ADDENDUM NO. 1

RE: CITY OF EMERSON, ARKANSAS
WALKING TRAIL IMPROVEMENTS

DATE: January 15, 2025

CITY OF EMERSON, ARKANSAS
 PARK / TRAIL IMPROVEMENTS
 PROPOSED SITE PLAN

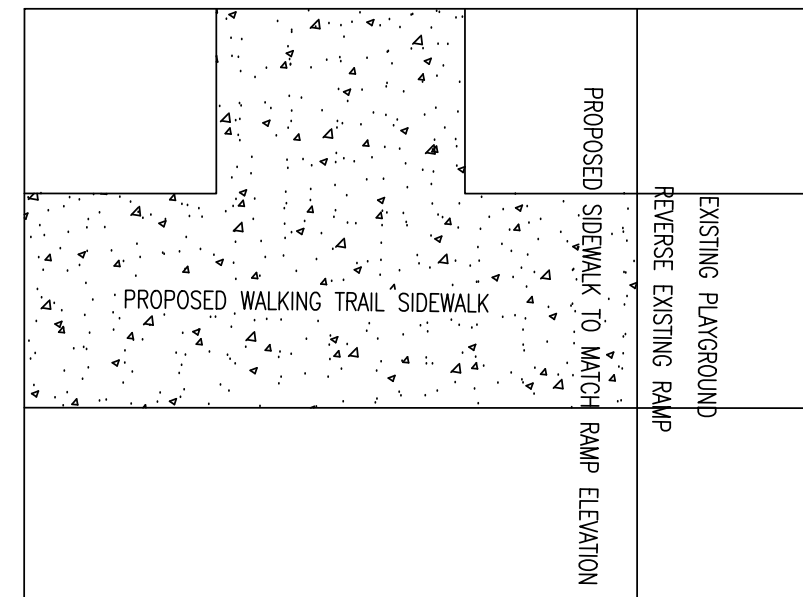
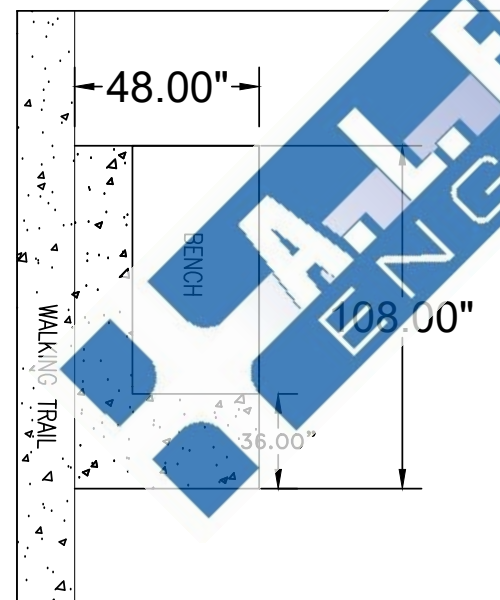
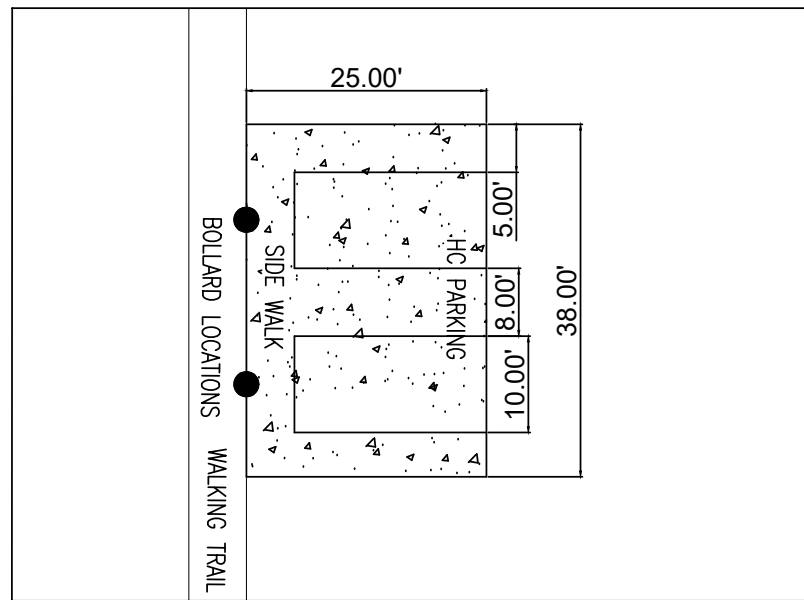
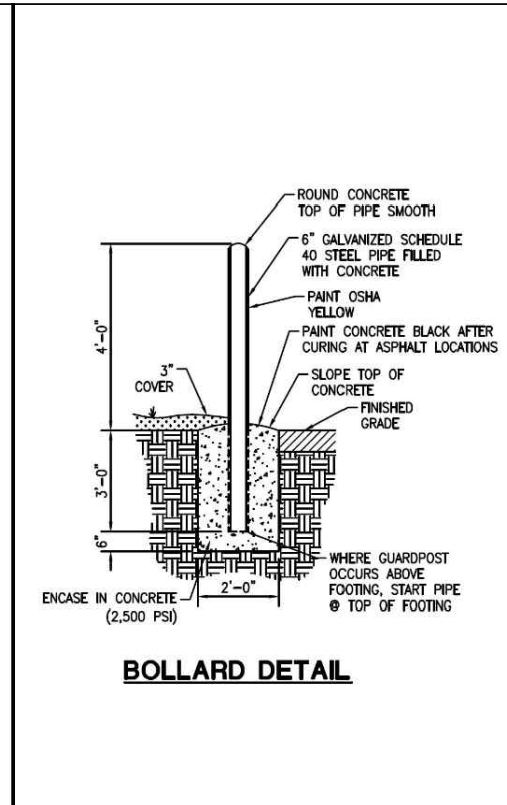
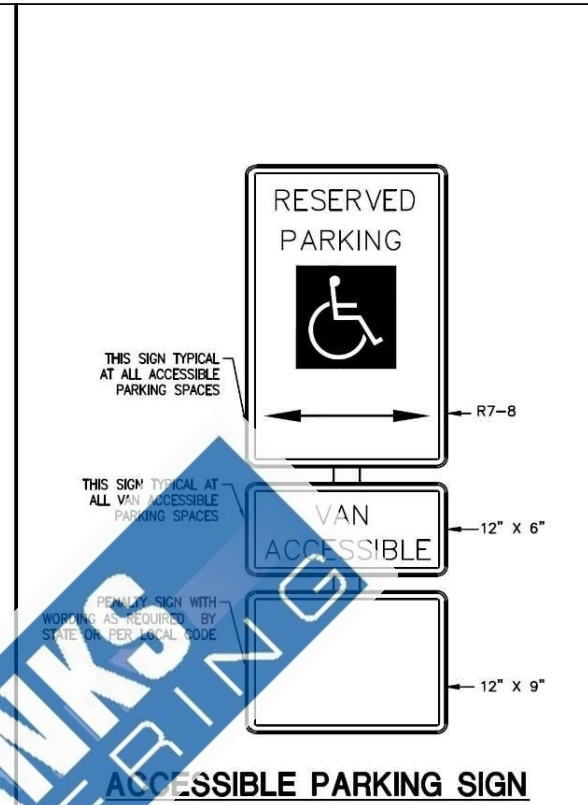
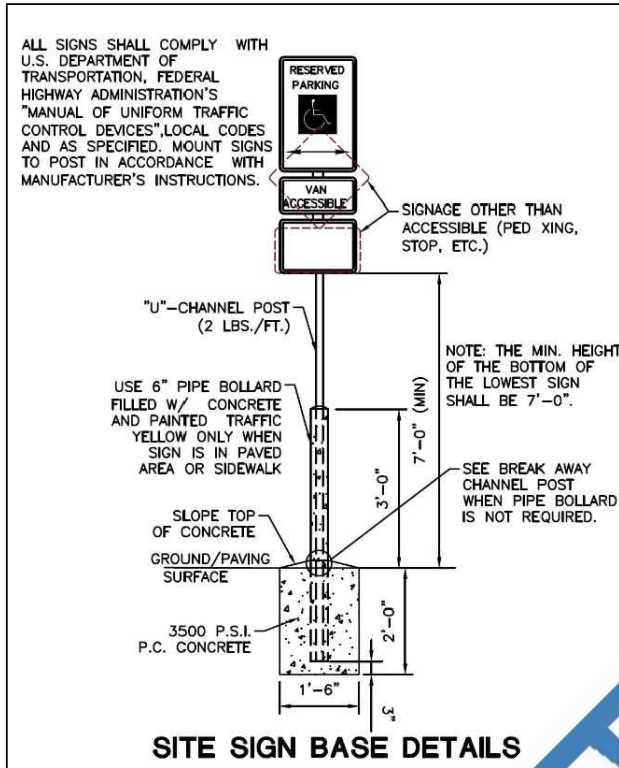
1. **Bid Proposal Update: Remove and Replace the bid proposal with the attached.**
2. **Add Appendix A to the end of the Technical Specifications. See the attached.**
3. **Plan Sheet Updated: See the update plan sheets 3 &4.**
